TO: Josh Lysen, Vice President Merit Homes  
 JOB SITE: Avalon East & West - 10633 128<sup>th</sup> Ave NE, Kirkland, WA 98033  
 SUBJECT: Tree Inventory & Assessment  
 DATE: March 3, 2014; Revised October 22, 2014  
 PREPARED BY: Sean Dugan,  
 Registered Consulting Arborist #457  
 ISA Certified Board Certified Master Arborist PN-5459B  
 ISA Qualified Tree Risk Assessor

Attachment 5 Public Comment  
SUB14-01032

Exhibit C---Overview of decision  
 Appeal of two short plats:  
 Avalon East : SUB14-01032  
 Avalon West: SUB14-01033

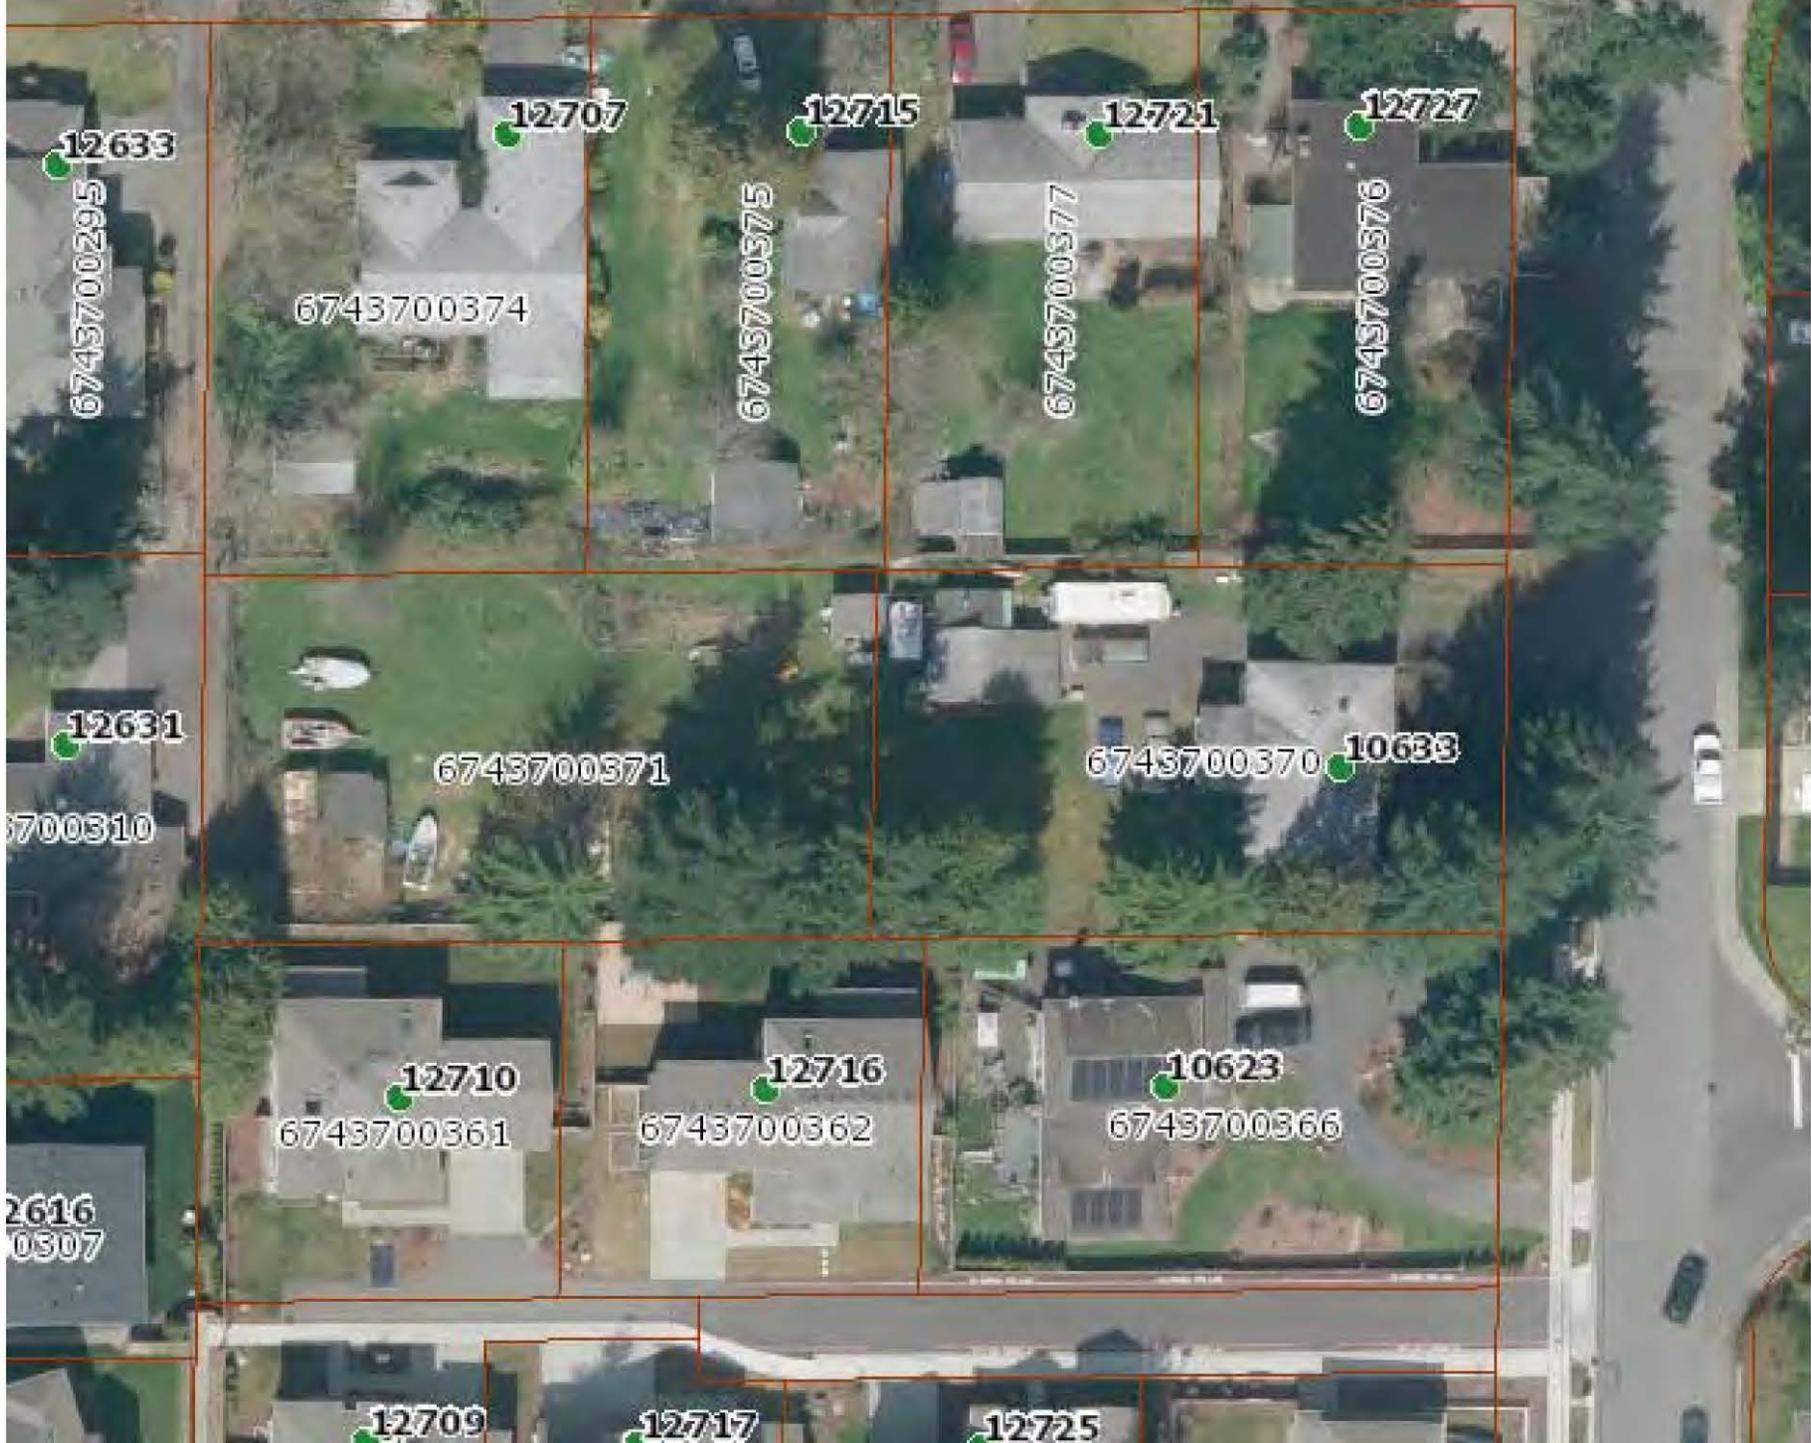
This stump is from another cut down tree that is not on the arborist report.

This tree was between #13 and #19 -- kind of hard for the arborist to miss it.

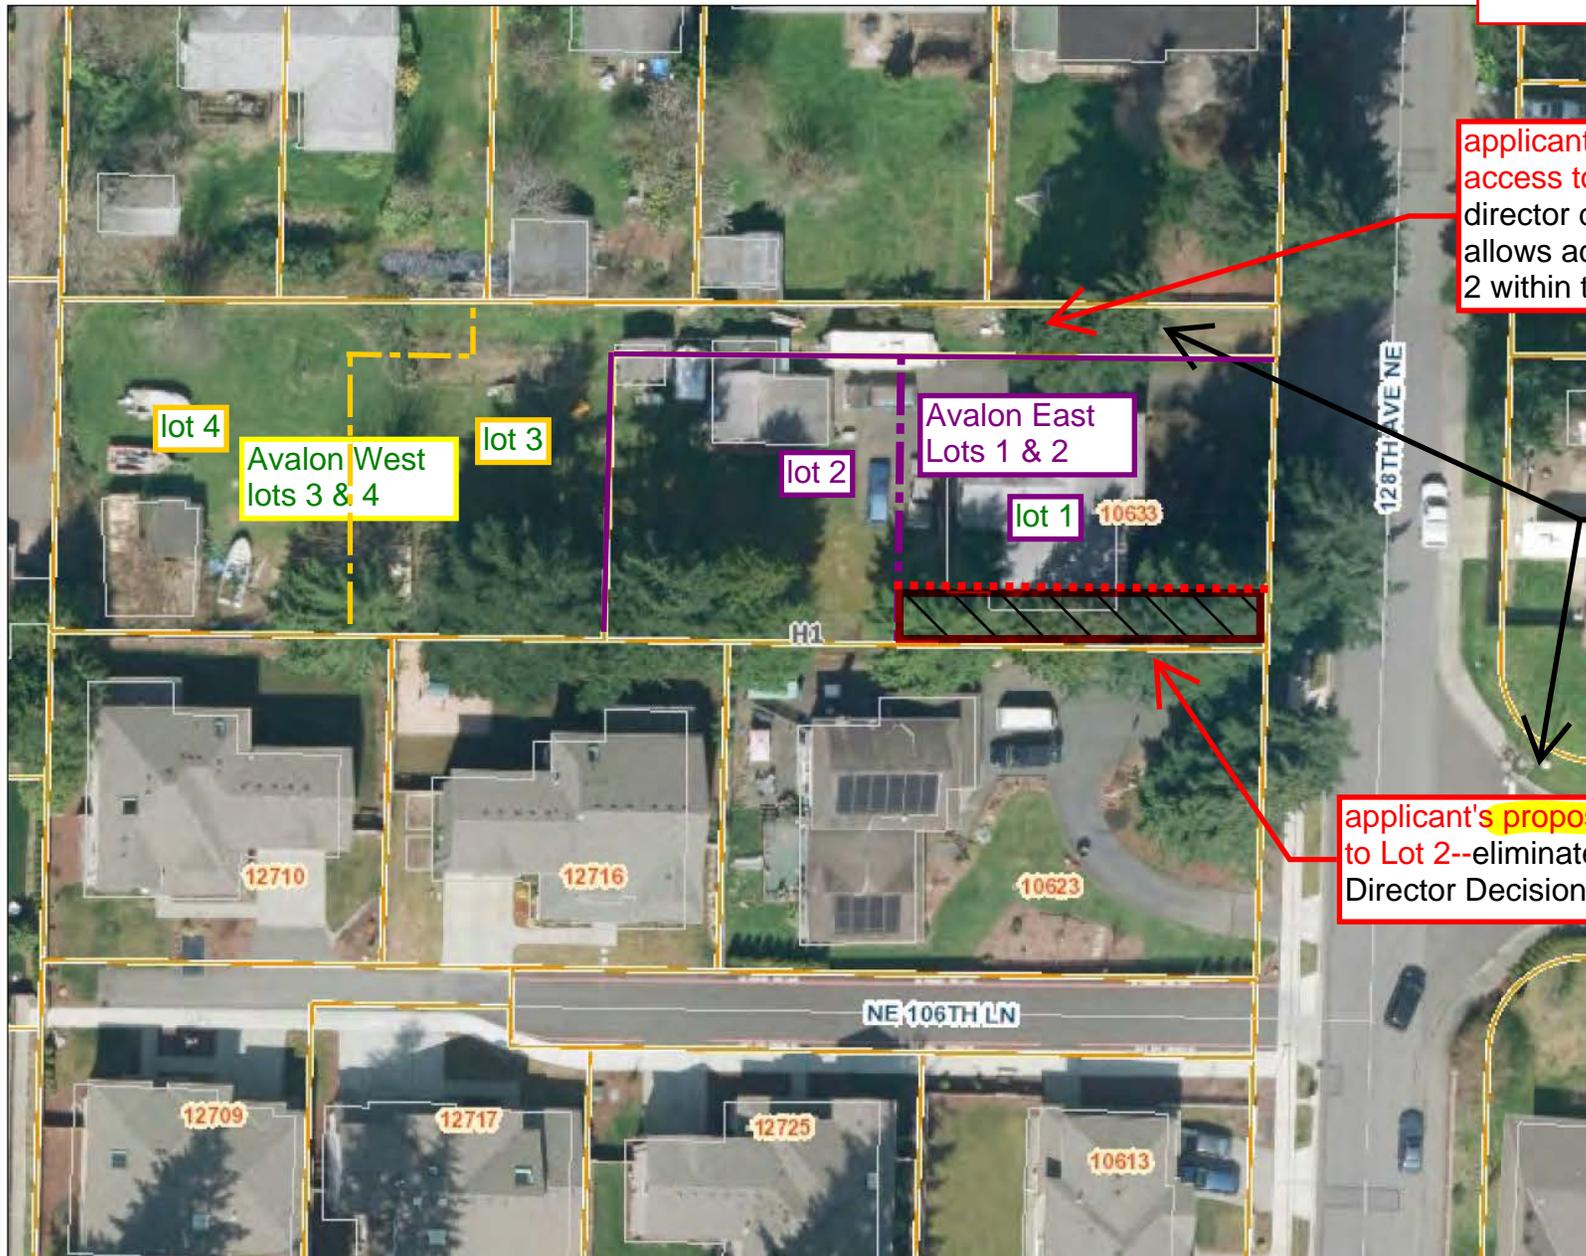
applicant's proposed access to Lot 3 and 4  
 director decision allows access to Lot 2 within this easement

applicant's proposed access to Lot 2--eliminated with Director Decision

Grid  
 Planning Director Decision changes access for lot 2 from proposed access to same access road as lot 3 and 4. This eliminates the proposed southern access road
